Norwest Marketown Planning Proposal

LPP Response Urban Design Package — 24/05/23

Local Planning Panel Advice

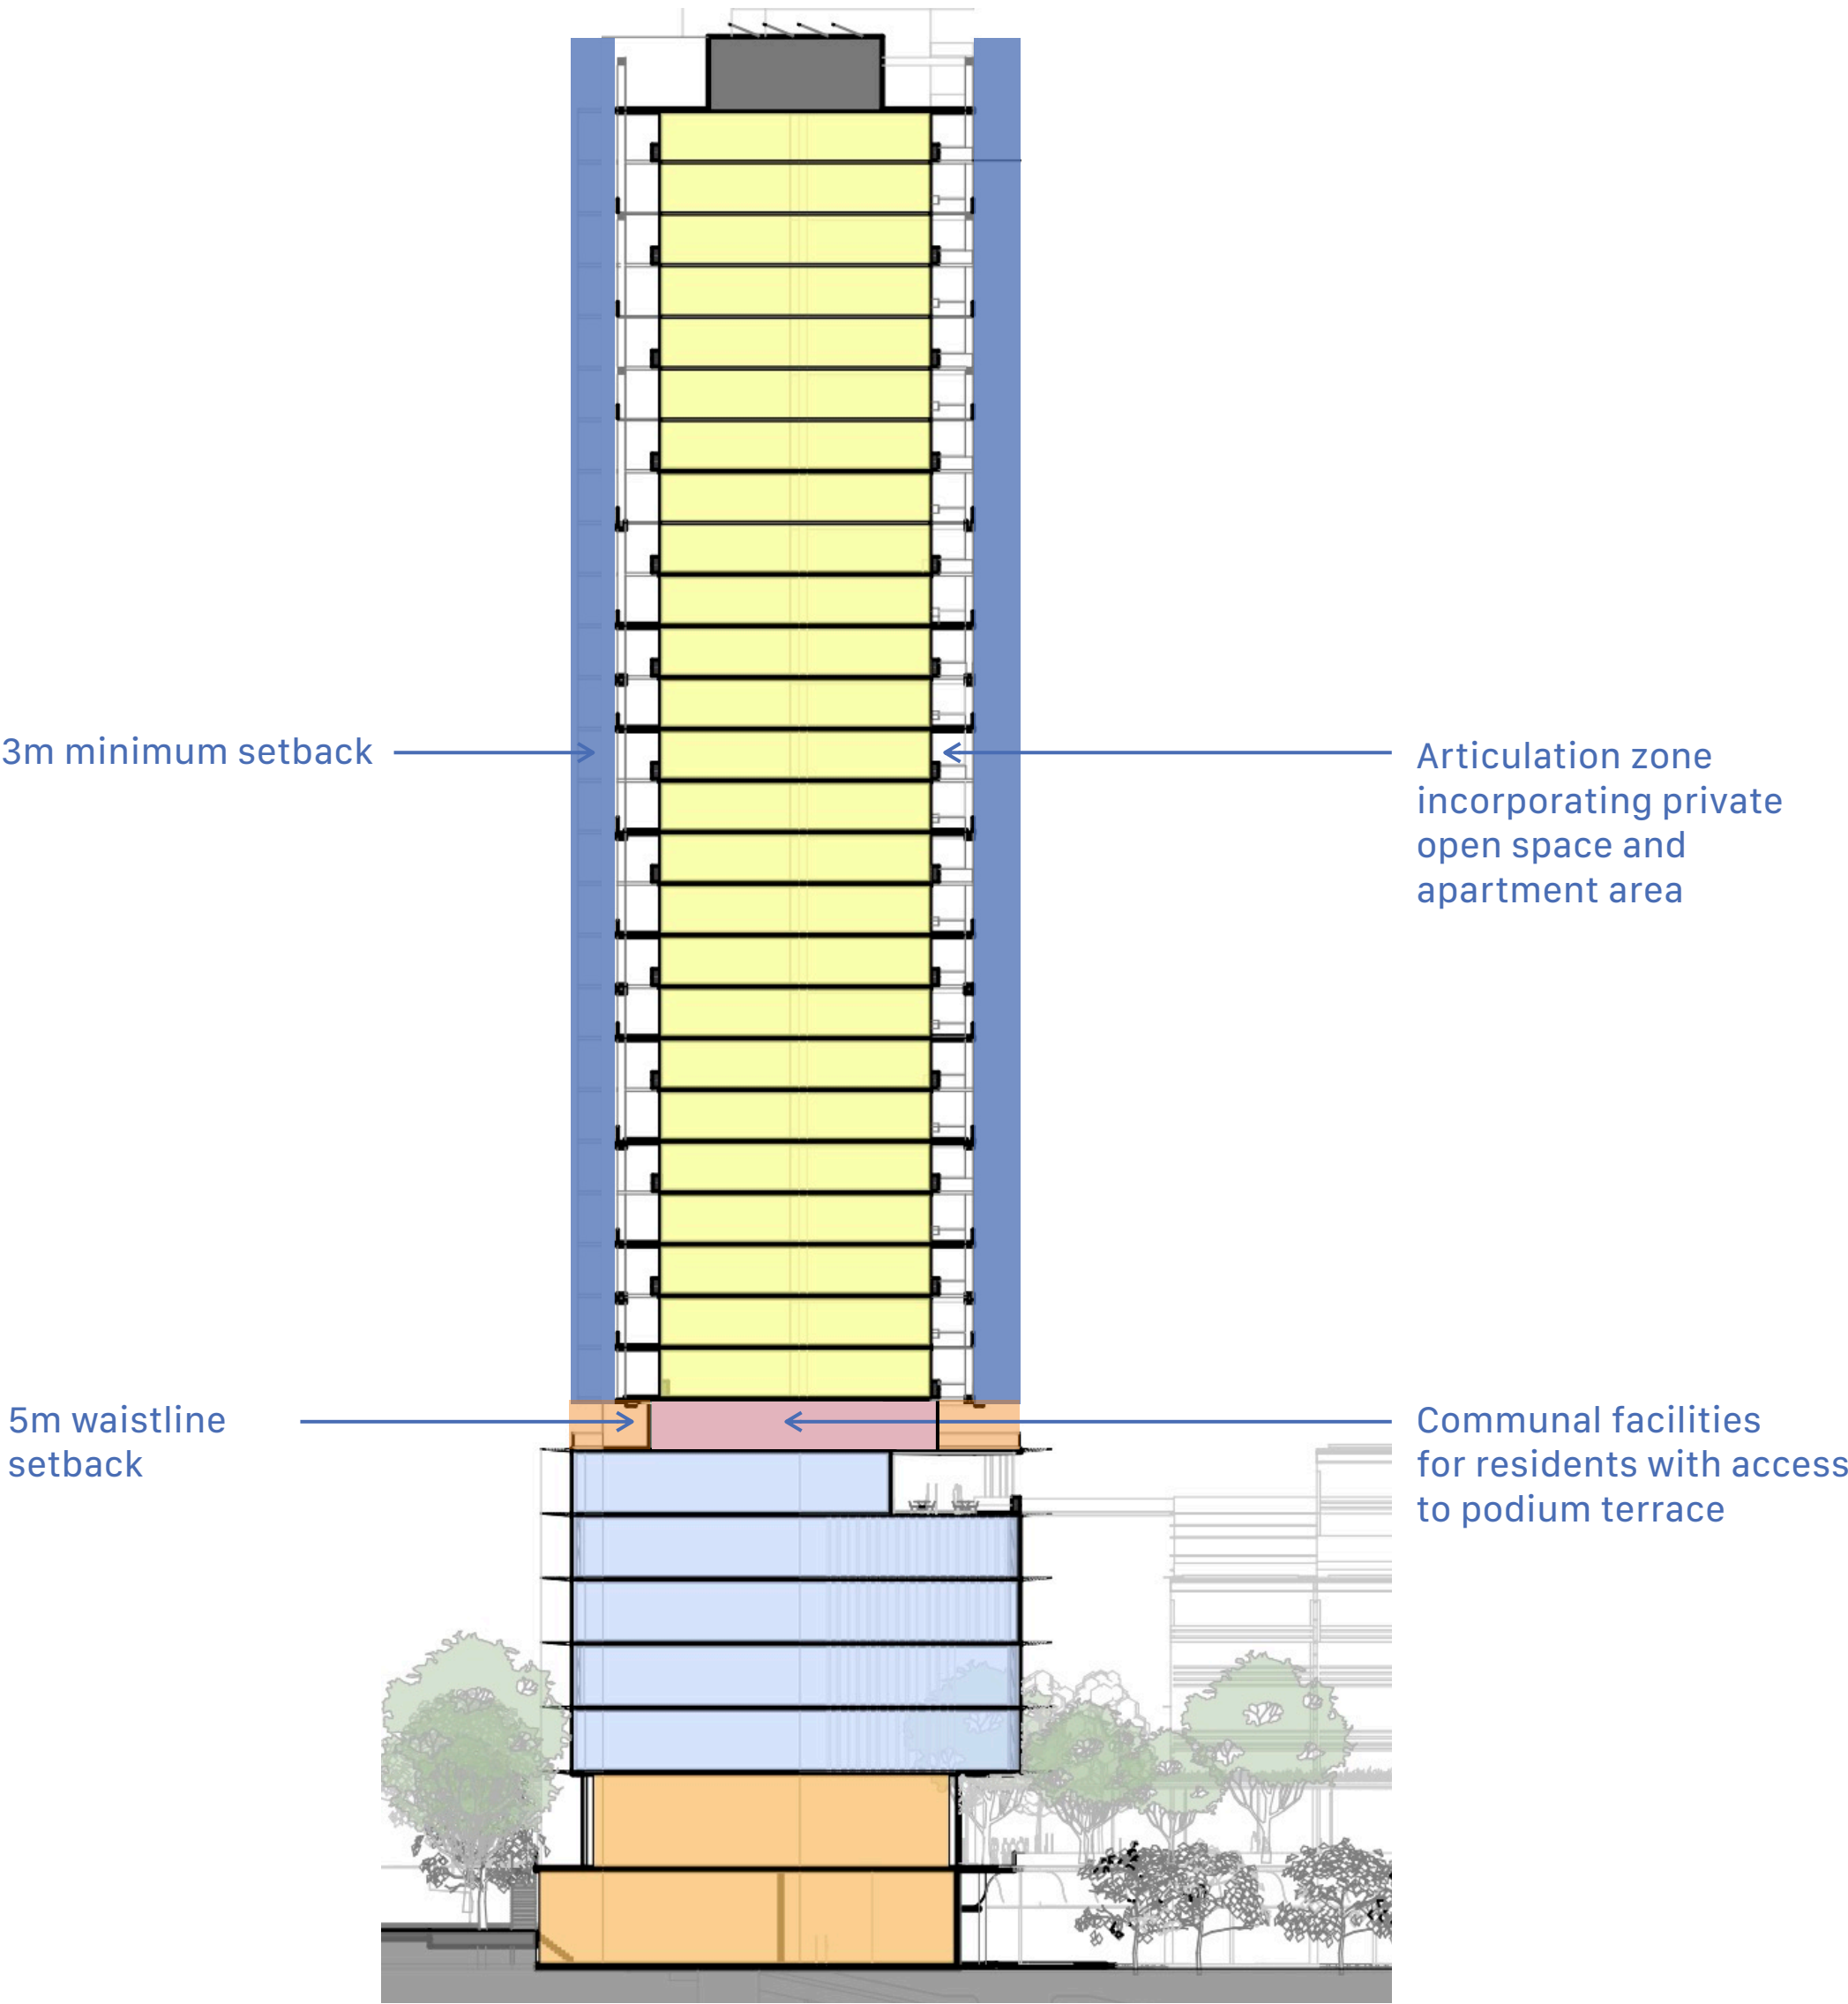
Minimum tower setbacks above podium of 5 metres (rather than 1.5 metres);

A section through Building B4 shows the minimum 3m setback above the podium consistently applied to the tower. The additional 2m to the first level above podium delivers articulation and creates external terraces for communal facilities. Apartment balconies further articulate the building form.

- 3m minimum setback
- Additional 2m waistline setback

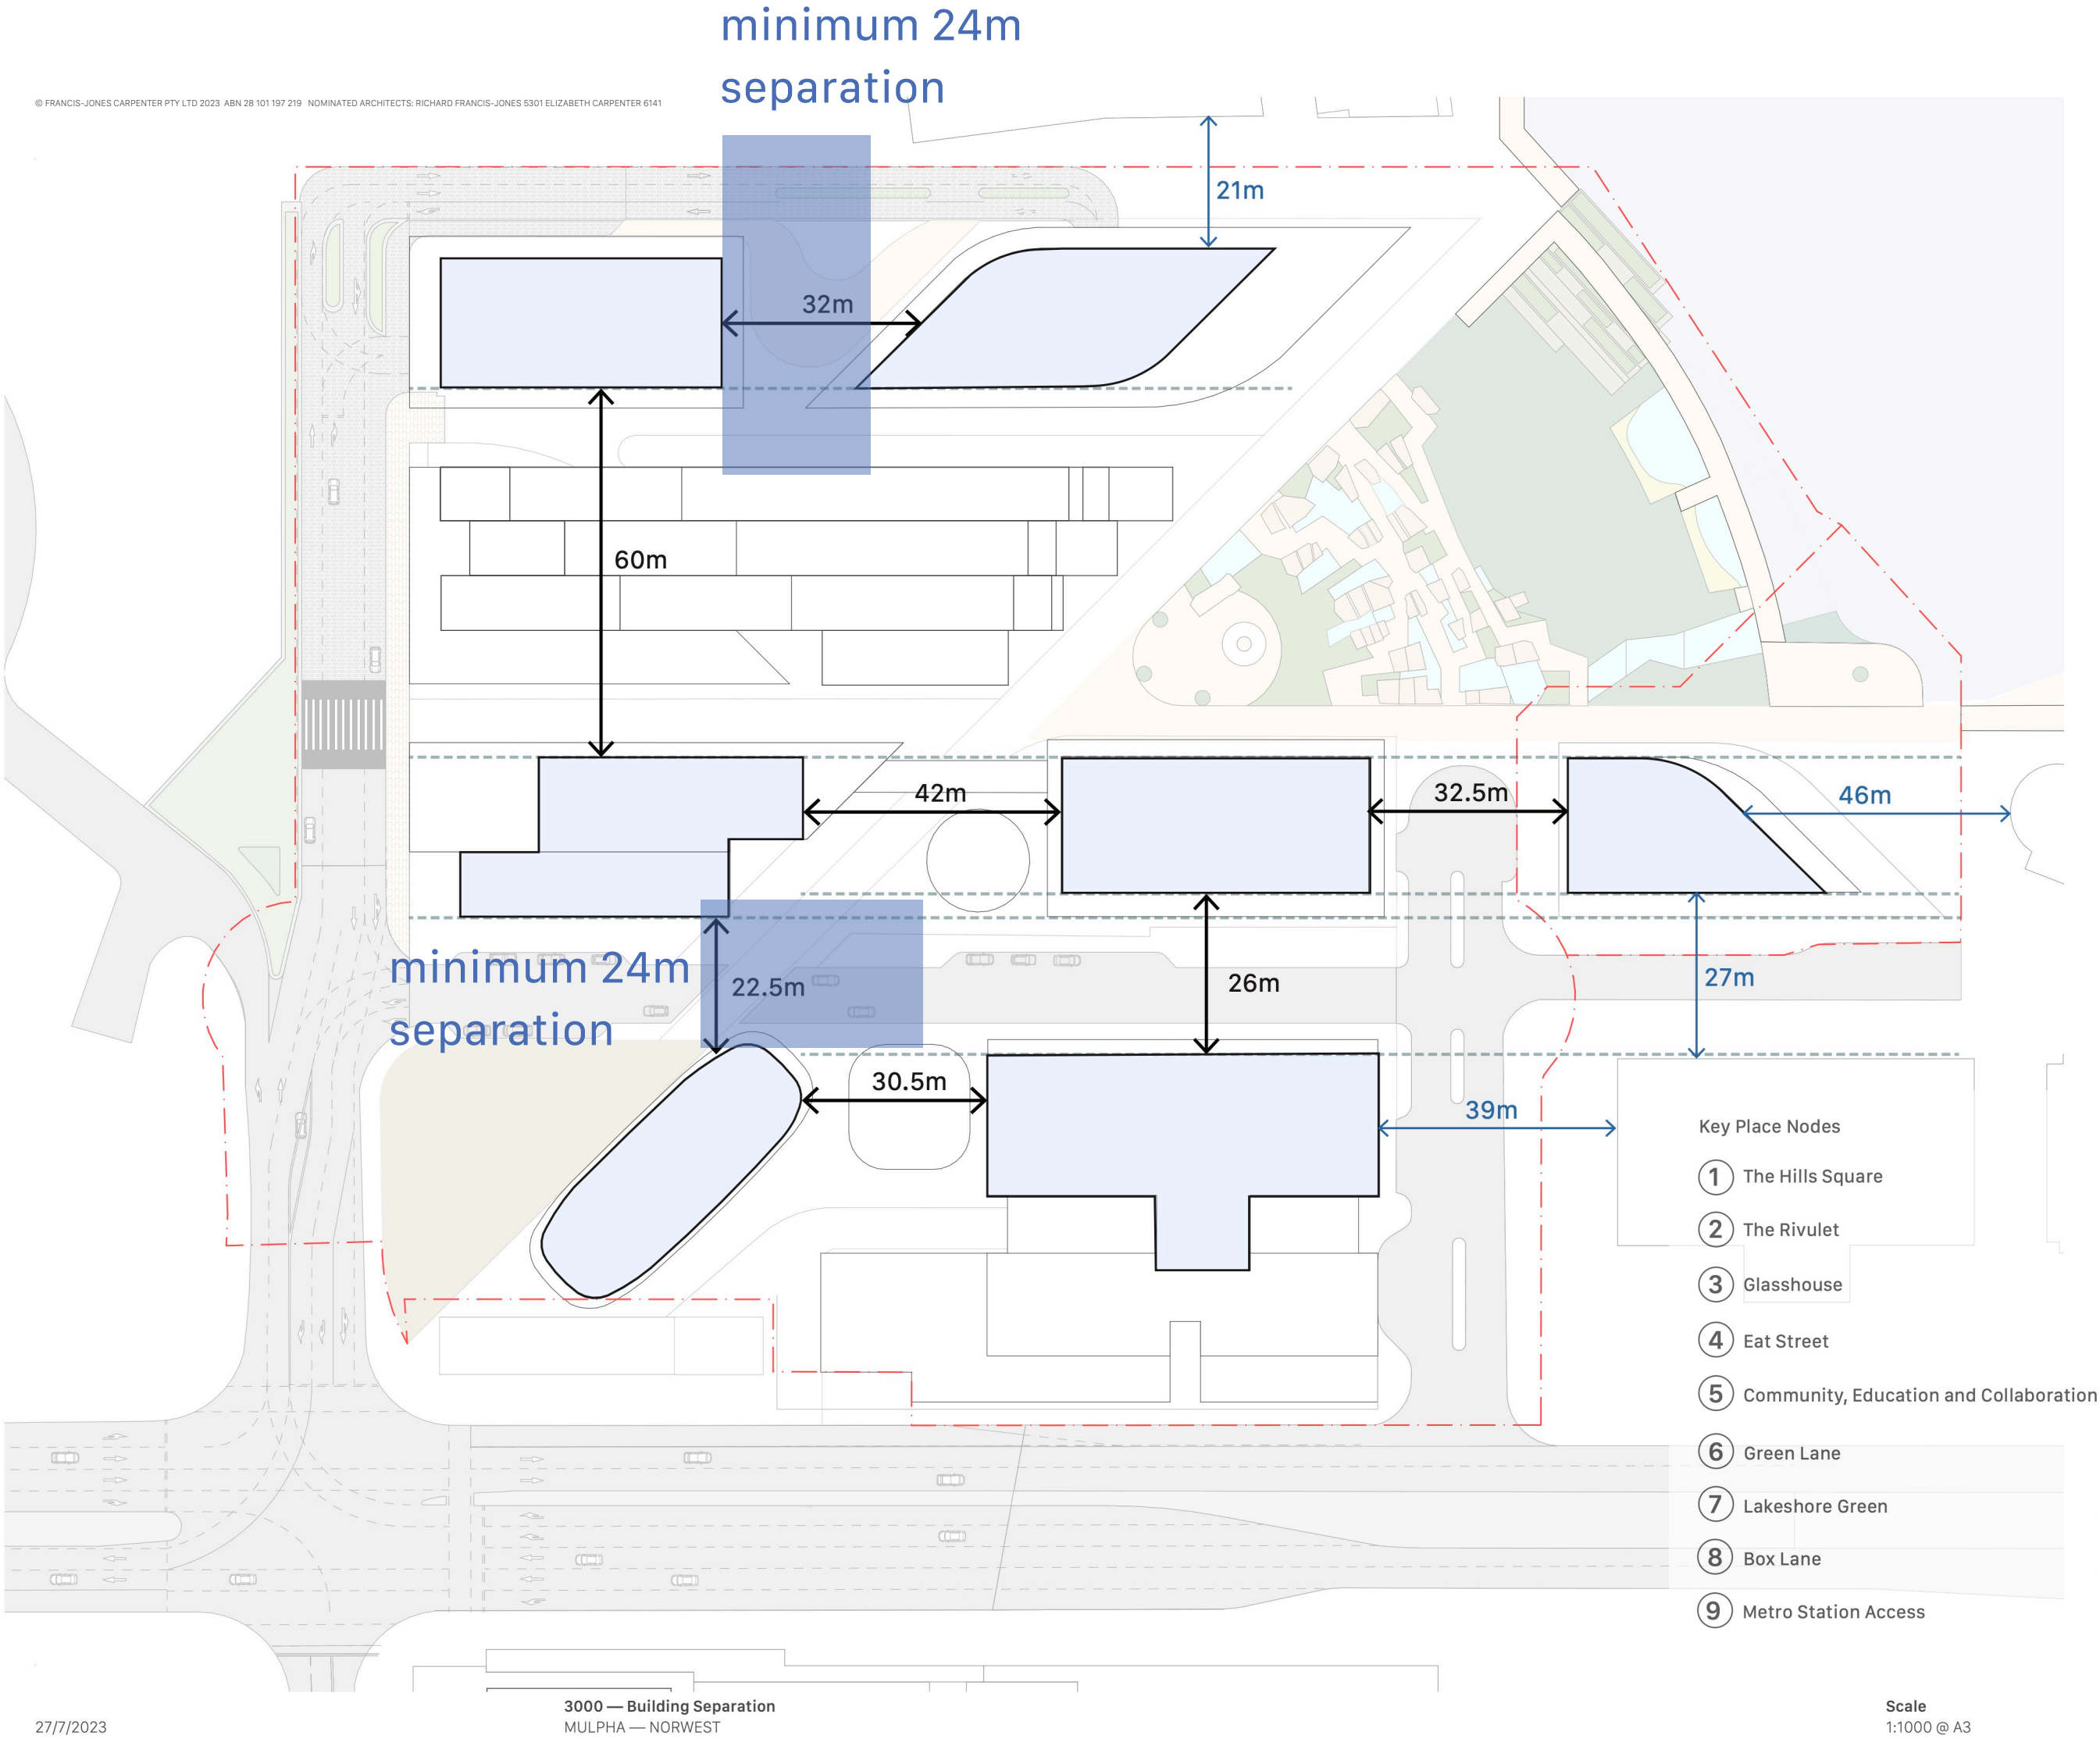
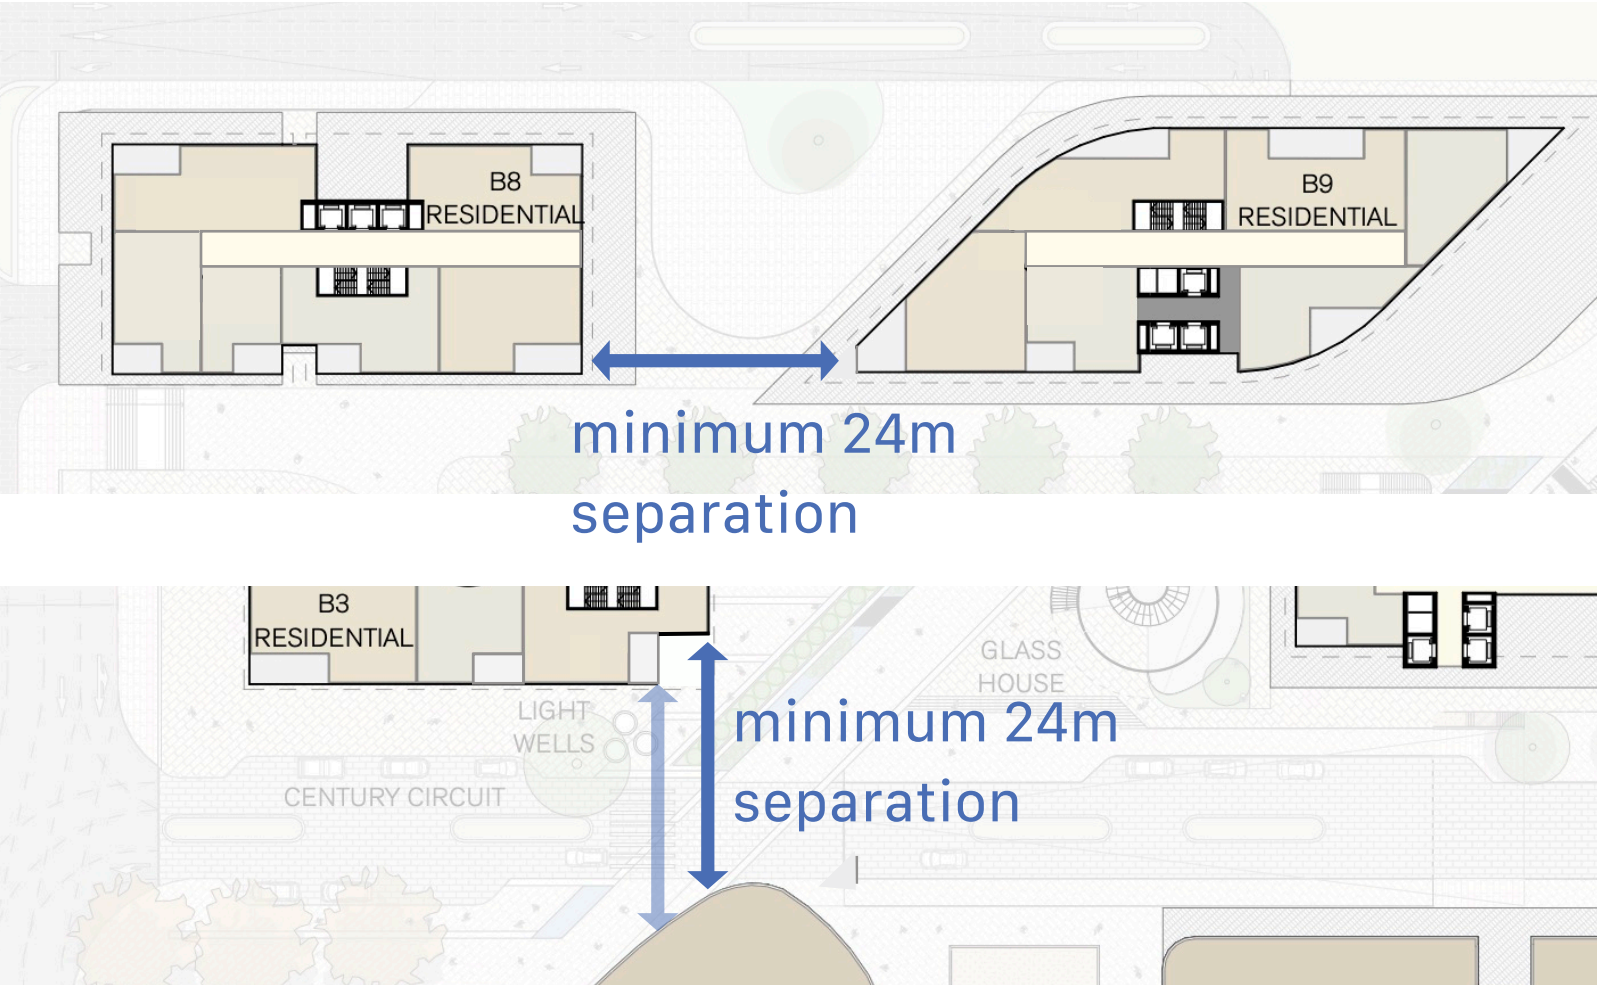
Minimum building separation of 24 metres above 8 storeys (rather than 20 metres);

It is the intention that all residential components of the Norwest Marketown Planning Proposal are fully aligned with the building separation requirements of the Apartment Design Guide {ADG}.

We acknowledge that a distance of less than 24m can be measured from the acute point of one residential building envelope to the corner of the adjacent residential tower. An ADG separation of 24m can be readily achieved in detailed design between residential buildings.

A minimum separation distance of 24m is preferred between residential and commercial buildings. One instance at corner points measures at 20.6m. The minimum separation of 24m can be readily achieved in detailed design.
